# CHANGE ORDER

PROJECT:  
Meadowdale Beach Park and Estuary  
Restoration Project  
PW-002-21SB

CHANGE ORDER NO: 2

# Construction Change Directive

**MEADOWDALE BEACH PARK AND ESTUARY DESIGN**  
 PPN 19-103913LDA  
**EXISTING CONDITIONS PLAN (3 OF 3)**  
 SHEET # 9 OF 81

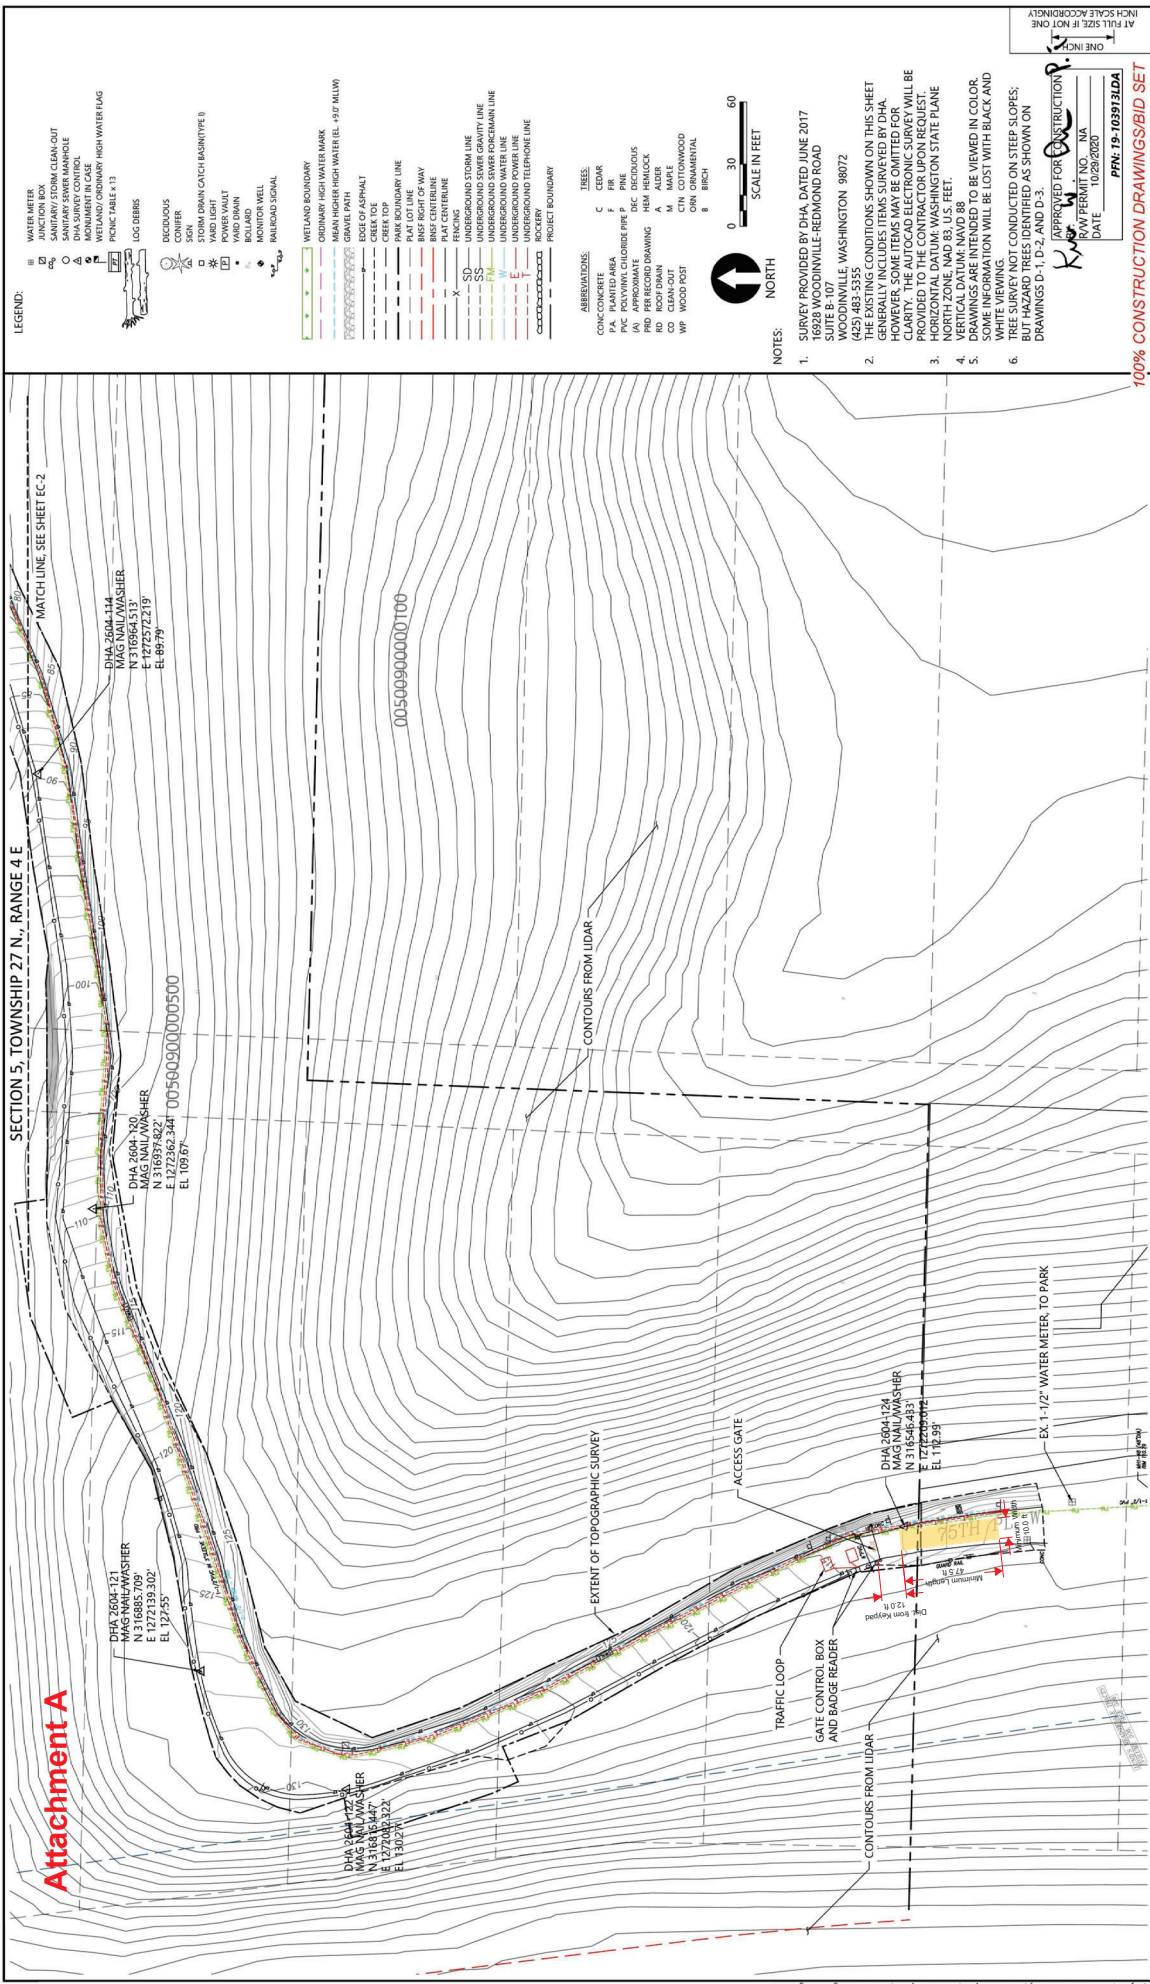
1. Cost to procure 78 22-foot-long spiralnails and spider hubs, and install 63 spiralnails and spider hubs, spaced 5 feet horizontally and vertically, at the location near the park entrance shown on the attached drawing (referred to as the fourth area). The remaining 15 spiralnails and spider hubs will remain in reserve for additional reinforcement if needed. Provide the two costs as separate line items.

2. Cost change that resulted from reducing spiralnail length from 30 feet to 22 feet for the upper reinforcement area (STA 2+44 to STA 3+24).
3. Cost to procure and install steel plates, temporary pavement patch material, traffic delineators, and other materials necessary to install and maintain steel plates on the roadway surface at the location indicated in the attached annotated project drawing EC-3, and per the requirements described in the Plate Specifications (Attachment 1) for a period of four months. This item includes removal of steel plates, temporary pavement patch, traffic delineators, and other materials associated with this installation and restore the roadway surface to preconstruction conditions or similar.

4. Cost to procure, install and maintain steel plates for a four (4) month period, along access road (STA 4+50 to STA 5+40). This item includes removal of steel plates, and other materials associated with this installation and restore the roadway surface to preconstruction conditions or similar.

This document specifies the requirements for steel plates and traffic delineators to be placed along 75<sup>th</sup> Place in the location indicated in the attached annotated drawing sheet EC-3 (Attachment A).

1. Steel plates must be at least 1 inch thick and fabricated to meet ASTM A36 steel requirements.
2. Steel plate area must be of sufficient width that all truck wheels bear on the plate.

3. Steel plates shall be placed toward the easterly roadway edge, away from the block retaining wall along the westerly road shoulder.
4. Traffic delineators must be placed along the west edge of the steel plates to prevent trucks traveling outside the steel plate area.

5. Steel plates must be without deformation. The plate surface must not deviate more than 1/4 inch when measured with a 10-foot straight edge along the length of the plate.

6. Contractor must ensure the steel plate withstands the traffic loading, remains in place, does not rock, does not generate noise, and is fully supported for the length of time the plate is in-place.

7. Steel plates shall be installed to resist bending, vibrations, etc., under traffic loads and shall be anchored securely to prevent movement.
8. If plates begin to vibrate, generate noise, displace, or otherwise perform poorly under construction traffic loading, Contractor shall revise installation, replace sheets, add anchorage, or provide other repair measures as necessary to mitigate poor performance.

9. The edges of all plates must be highlighted with 12-inch minimum width Safety Orange (Federal Standard 595 Color 595 FS 12246 or approved equal) paint.

10. All steel plates must be bedded on temporary pavement patch Material or other suitable Material approved by the Engineer that extends beyond the plate's edge to form a tapered transition (shim).

11. The taper must provide a smooth, gradual transition between pavement and the plate at least 12 inches in length to accommodate wheelchair, bicycle, and other traffic.

12. The tapered transition shim must be highlighted with paint stripes consisting of the color Safety Orange approximately 2 inches wide on 16-inch centers.

13. Warning signs advising motorists that they should expect to encounter steel plates, shall be placed at approximately 100 feet in advance of the steel plate location.

14. Contractor shall provide a submittal that describes their proposed steel plate installation and includes sections, diagrams, material cut sheets, and other detail depicting the installation.
